METROPOLITAN GOVERNMENT OF NASHVILLE AND DAVIDSON COUNTY

STAFF RECOMMENDATION
1814 Boscobel Street
June 19, 2013

Application: New construction—Infill
District: Lockeland Springs-East End Neighborhood Conservation Zoning Overlay
Council District: 06
Map and Parcel Number: 08314032700
Applicant: William Wood, Synergy Development Group
Project Lead: Melissa Baldock, melissa.baldock@nashville.gov

PLOT PLAN

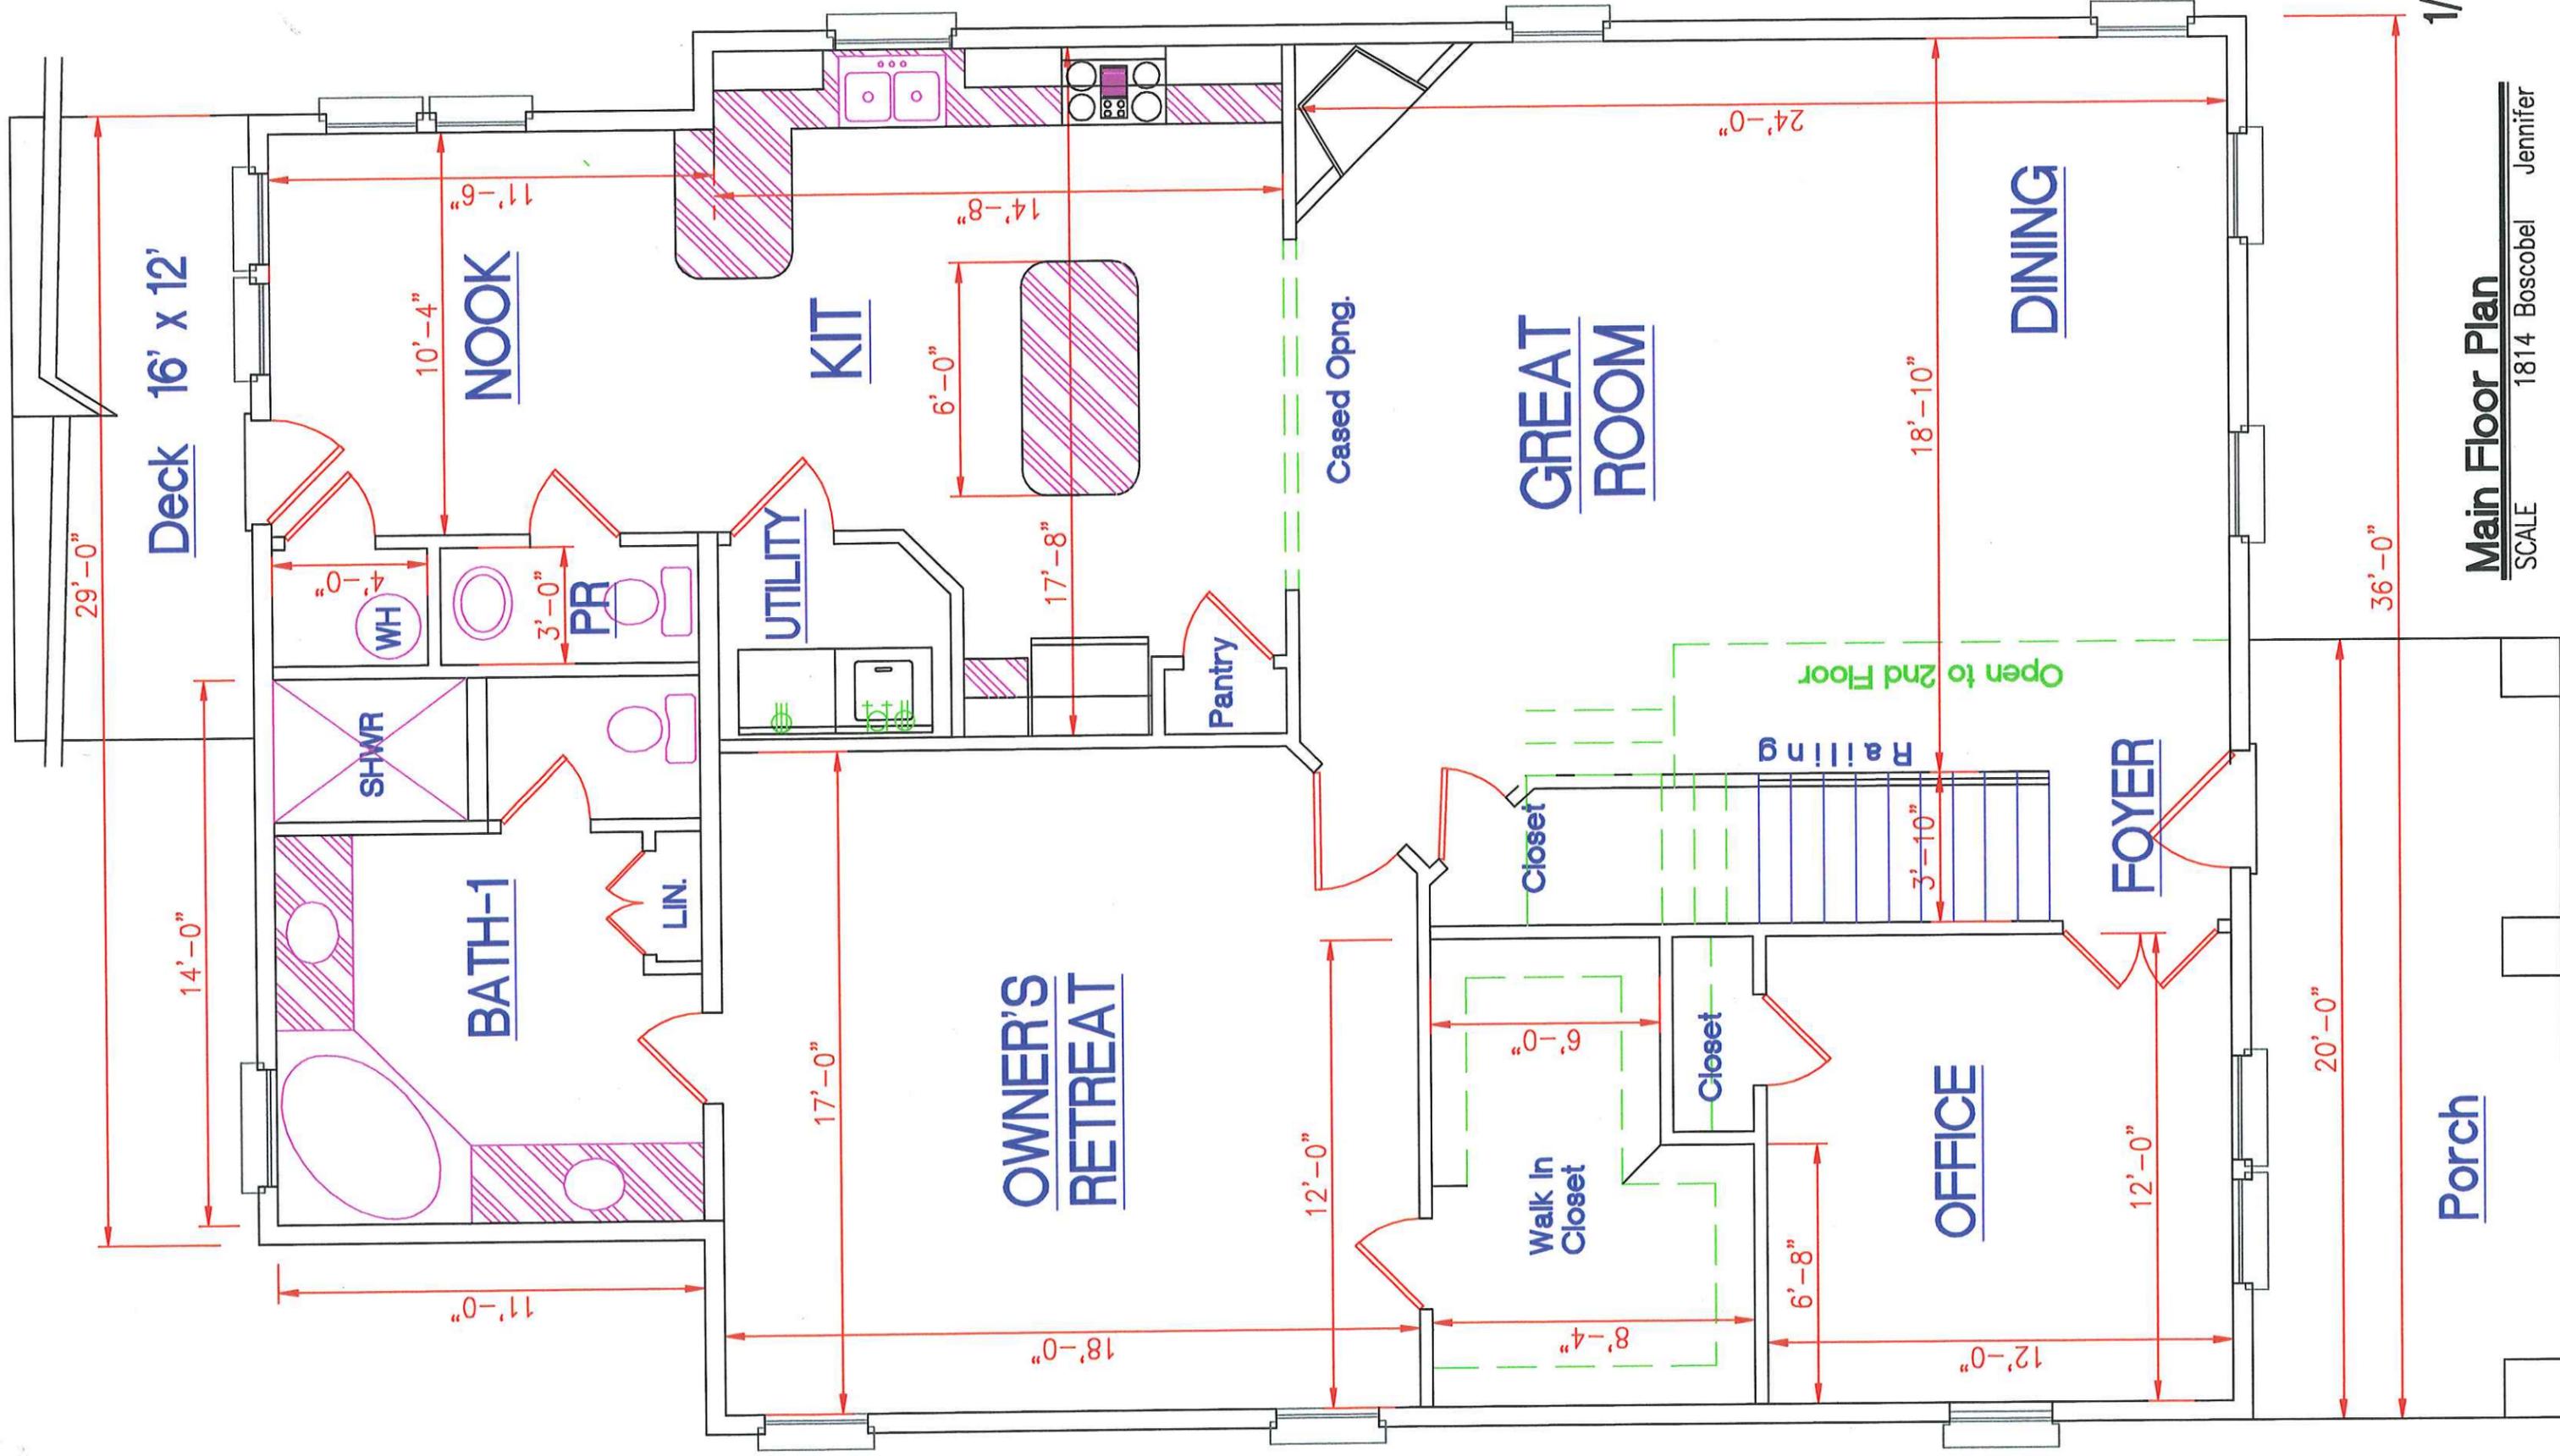
Setback and Rhythm of Spacing: The new infill will be centered on the lot and will meet all base zoning requirements for setbacks. The structure will be located seven feet (7') from each side property line, thereby keeping with the typical rhythm of spacing for the block. The front line of the house's porch will line up with the front line of the porch at 1810 Boscobel and will be pushed slightly forward from the house at 1816 Boscobel Street (Figures 2 & 3). Staff finds the setback and rhythm of spacing of the proposed structure to meet Section II.B.3. of the *Lockeland Springs-East End Neighborhood Conservation Zoning Overlay Handbook and Design Guidelines*.

Appurtenances & Utilities: The site plan does not call out any appurtenances, other than a silt fence which staff assumes will be installed temporarily during construction. Staff asks that the utilities be placed at the rear of the infill or on a side façade, beyond the midpoint of the house. In addition, staff asks to review and approve any permanent appurtenances, including fencing, driveways, lighting, pathways, etc.

Rear Elevation

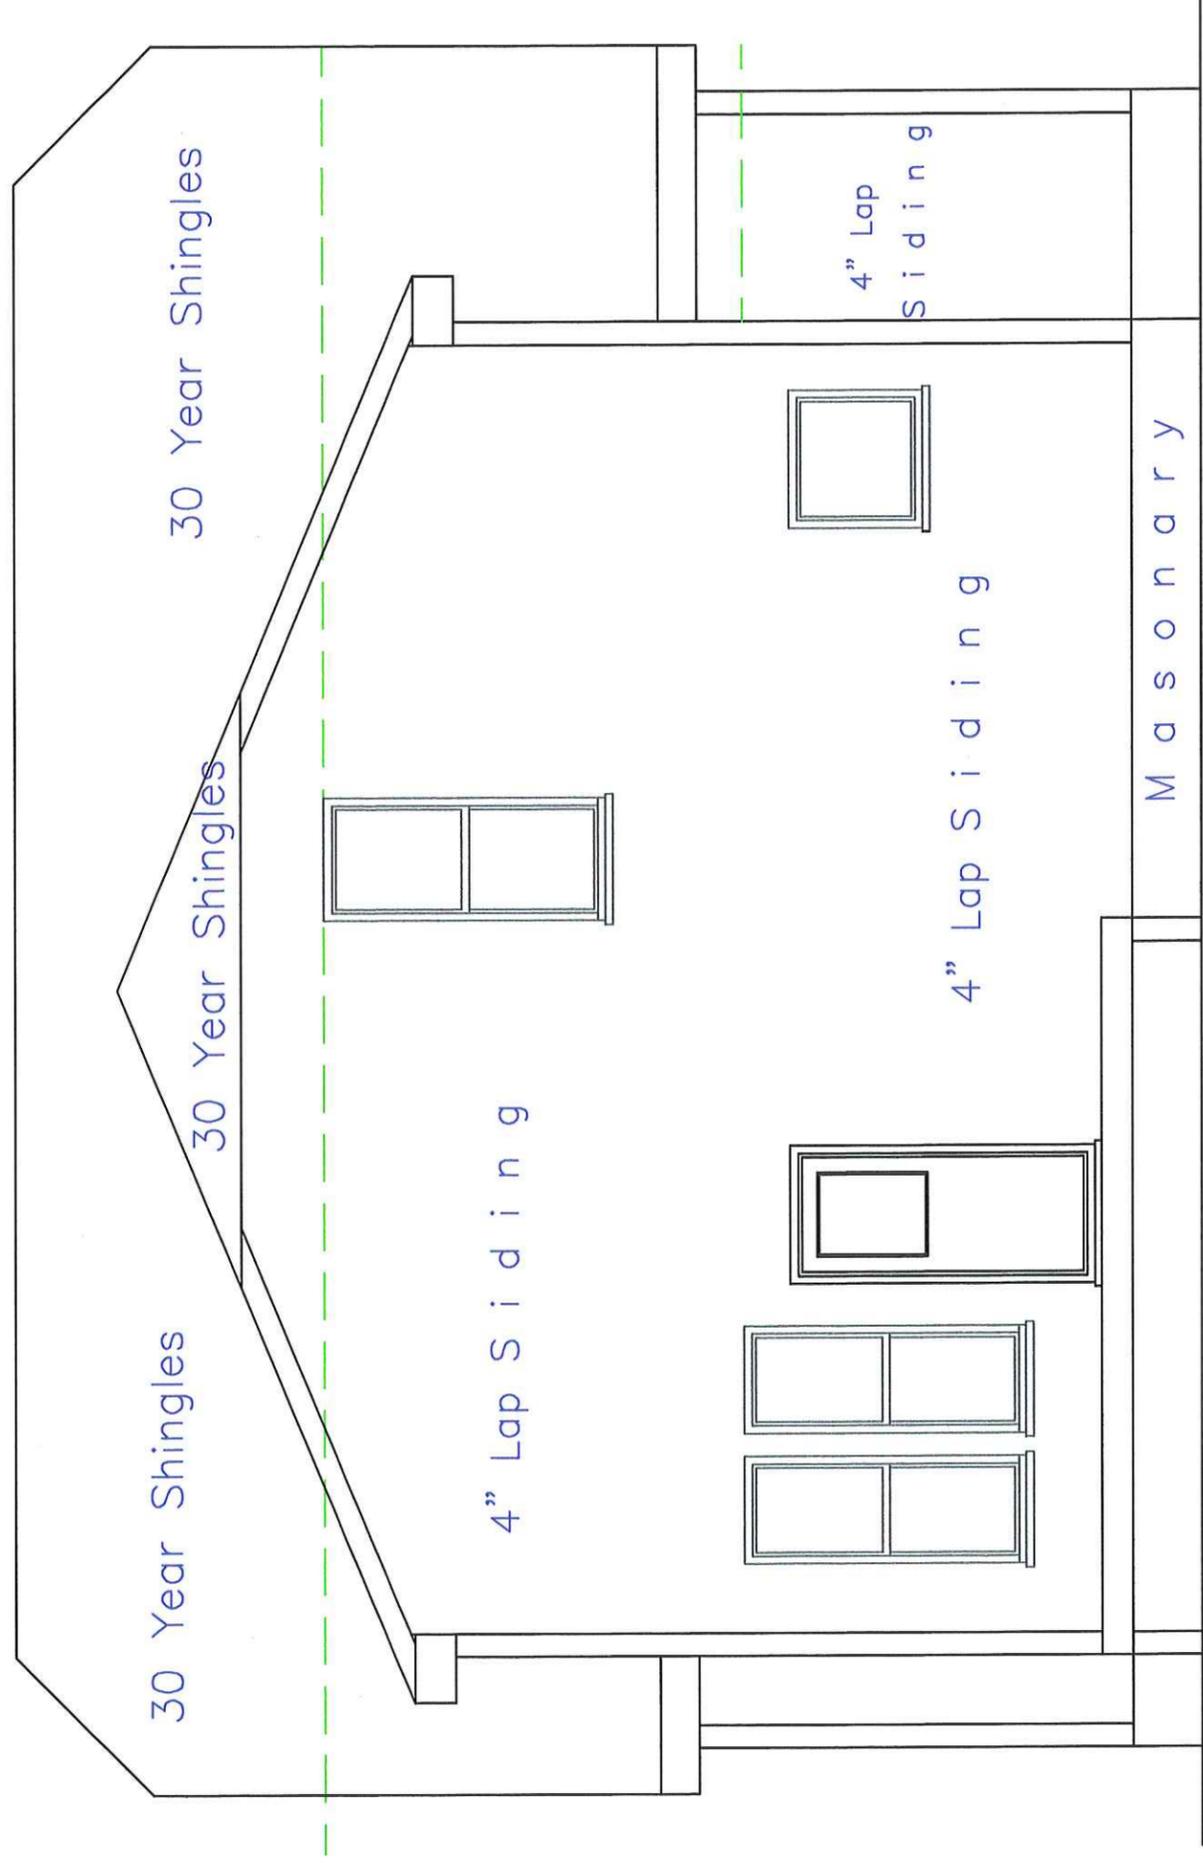
Staff notes that the drawings do not show a door frame around the front door, and asks that one be included. Likewise, the double windows on the front, rear, and right side elevations should have a frame around the pairs and a four to six inch (4"-6") mullion in between the windows. Staff also suggests that adding a band board on the side façades at the change in floor level will help break up the façade. Finally, staff asks that the front porch columns have a more substantial cap.

Front Elevation

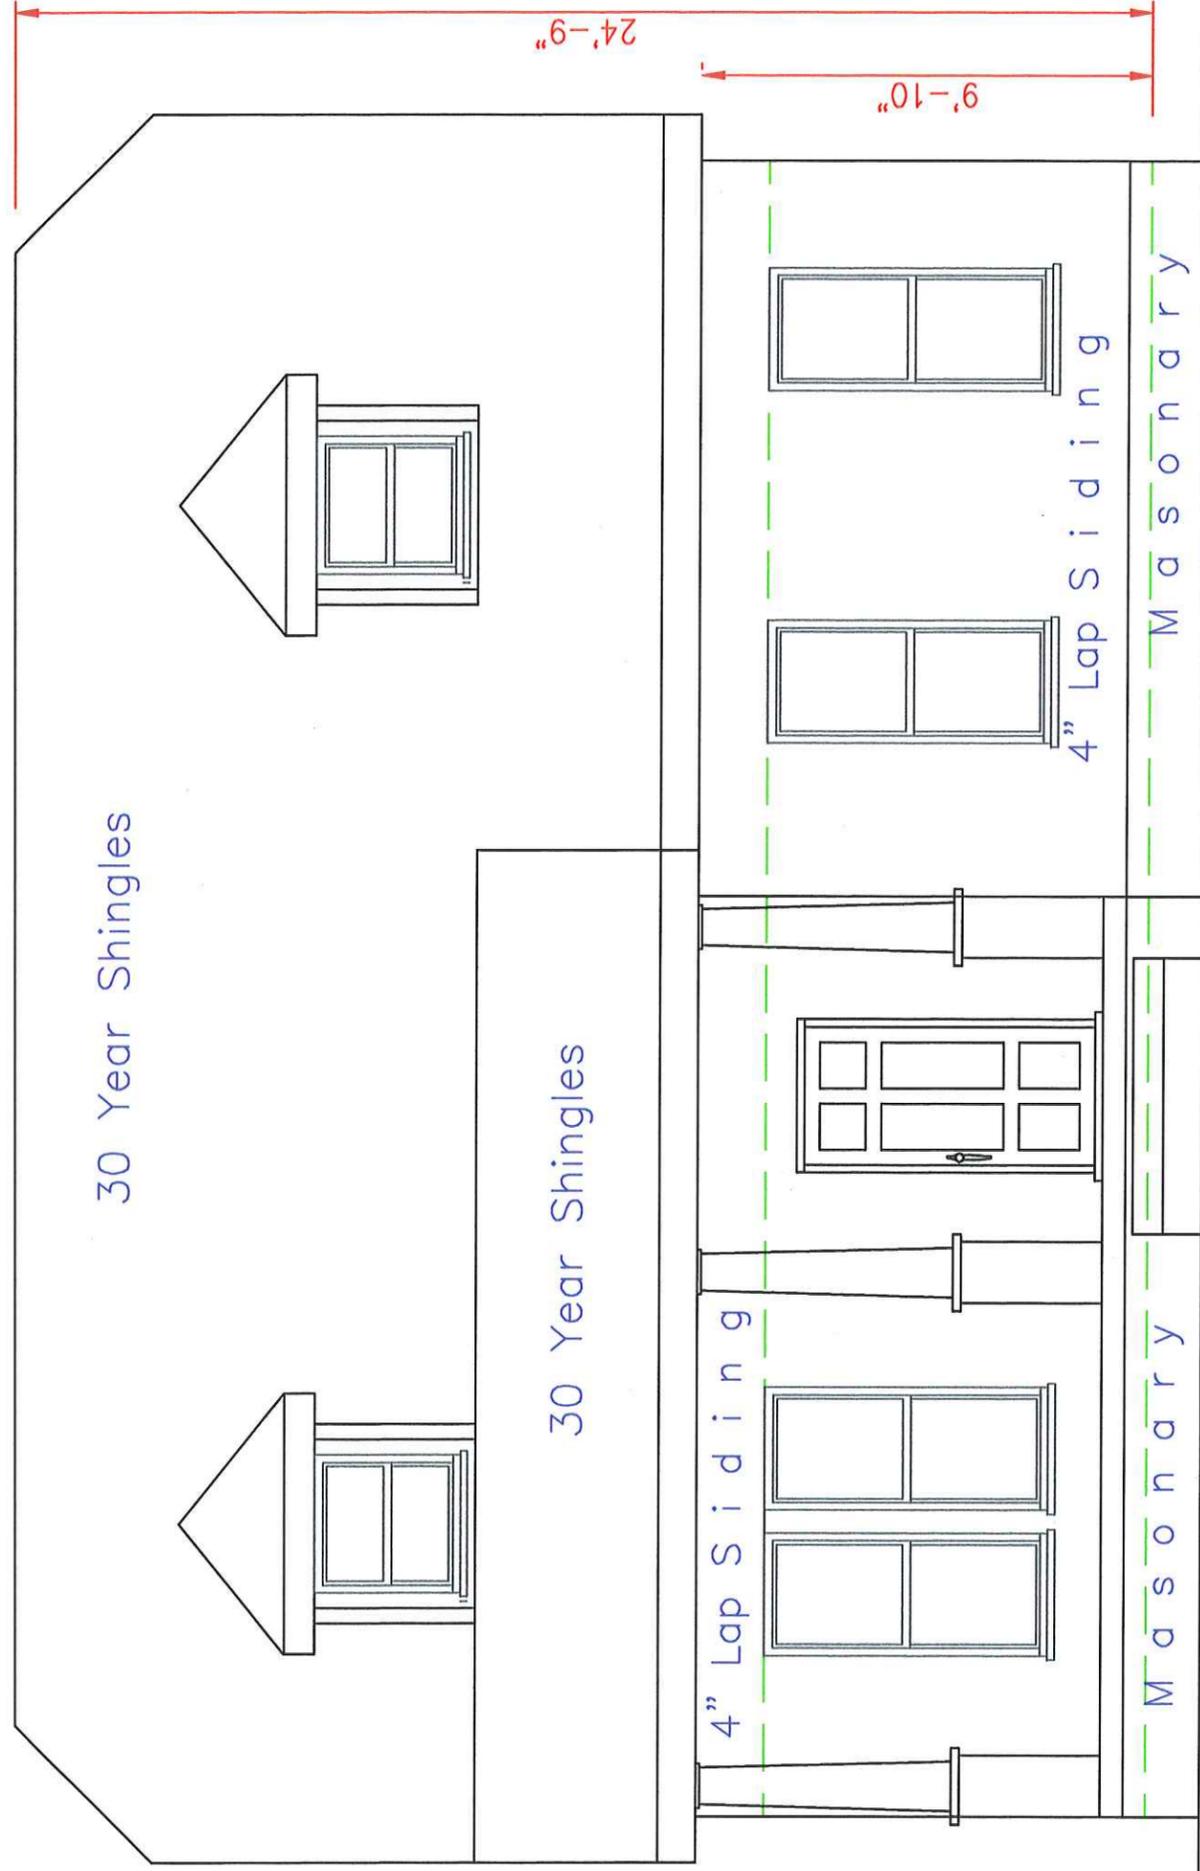
Two front dormers will have hipped roofs with 8/12 slopes. The dormers will be set back more than two feet (2') from the front wall of the house, which is appropriate. The dormers will be approximately four feet, six inches (4'6") wide and six feet, six inches (6'6") tall.

1. Staff review all final material choices, including the asphalt shingle color, window and door materials and design, the foundation material, and the materials for the porch columns, bases, and floor;
2. A door frame on the front façade and a band board on the side facades be included;
3. The front porch columns have more substantial caps;
4. All double window openings have a window frame around the pair and a four to six inch (4"-6") mullion in between the windows;
5. The utilities be placed at the rear of the house, or on a side façade beyond the midpoint of the house.
6. Staff review and approved any appurtenances, including driveways, pathways, fencing, and lighting.
